KeContact P30

Software release notes Package 1.6.3

Version date: 16.04.2018

3.2.3. Connector ID assignment

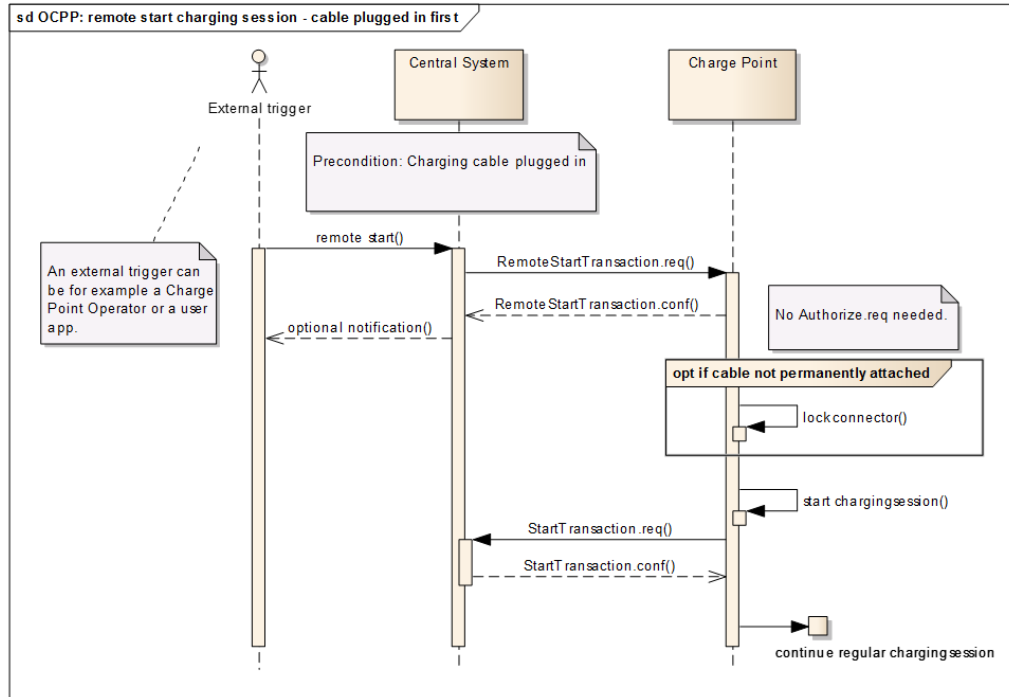
The user can assign the connector ID to a specific serial number directly via the web interface.

Remote start charging session – cable plugged in first

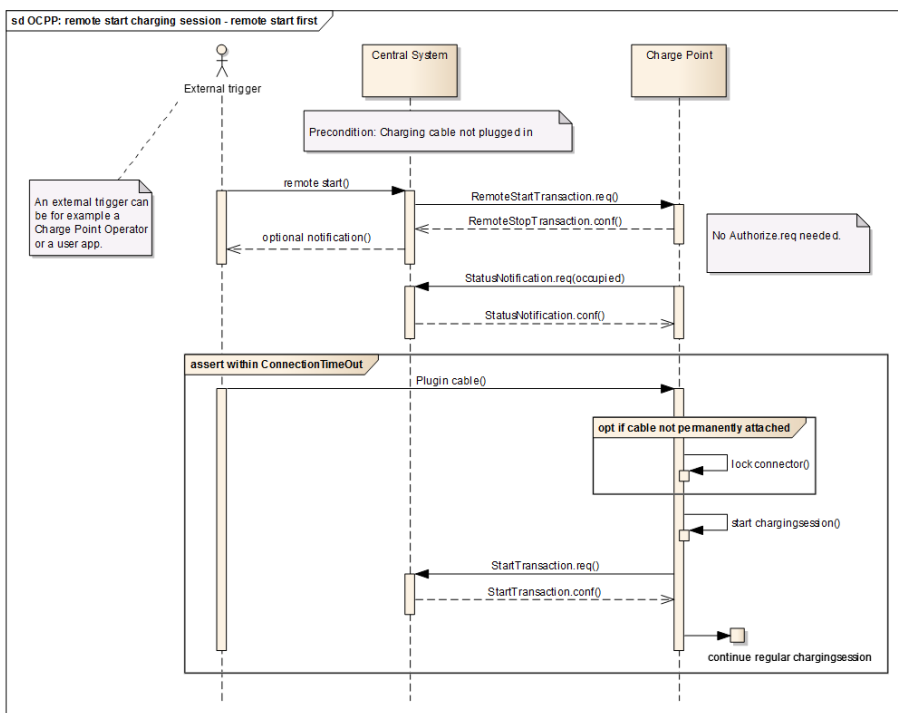
3.2.5. Remote Start Transaction sequence

The Remote Start Transaction sequence has been modified so that the P30 replies immediately after receiving the Remote Start Transaction request.

5.2.1. Unused logs have been removed

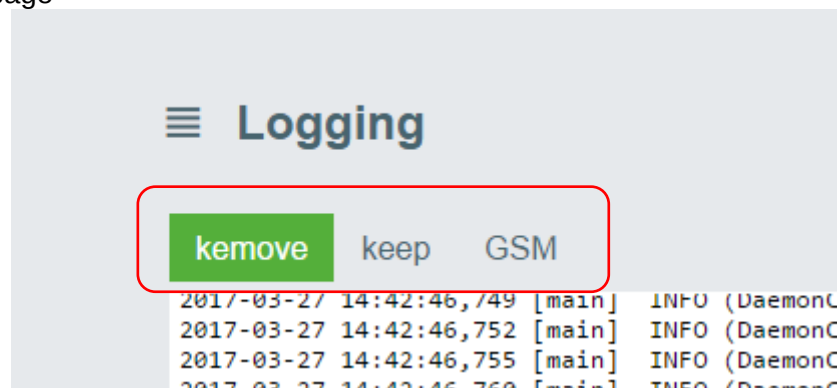
Unused tabs like "kremove-wrapper" and "keep-wrapper" have been removed from the logging web page.

6.3.5. WebUI – Logging

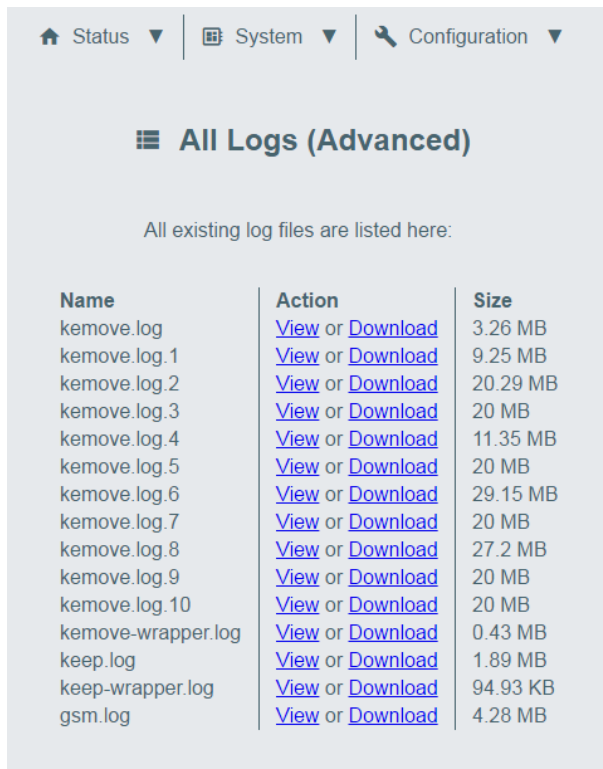
Added "All Logs" button to "Logging" tab, allows individually viewing and downloading every single log file.

Here is shown a screen shot of what the user can see if clicking on “ All Logs”.

6.3.7. WebUI – component version

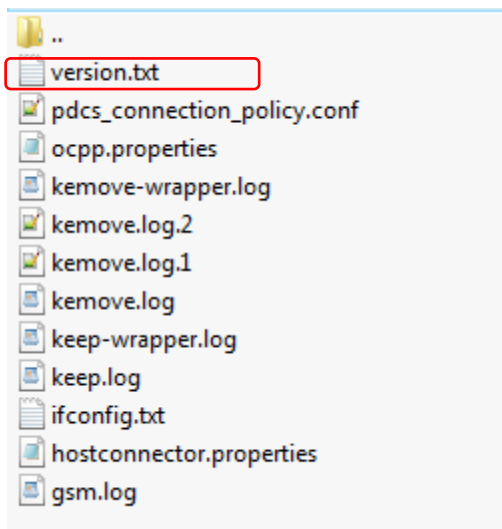
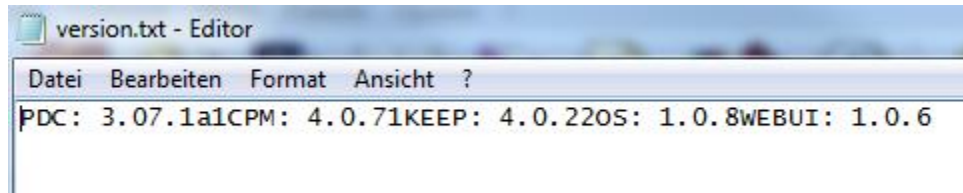
Added the text file “version.txt” in zip file accessible by clicking on "Download Latest".

In this file are enclosed the information related to the versions of the software component.
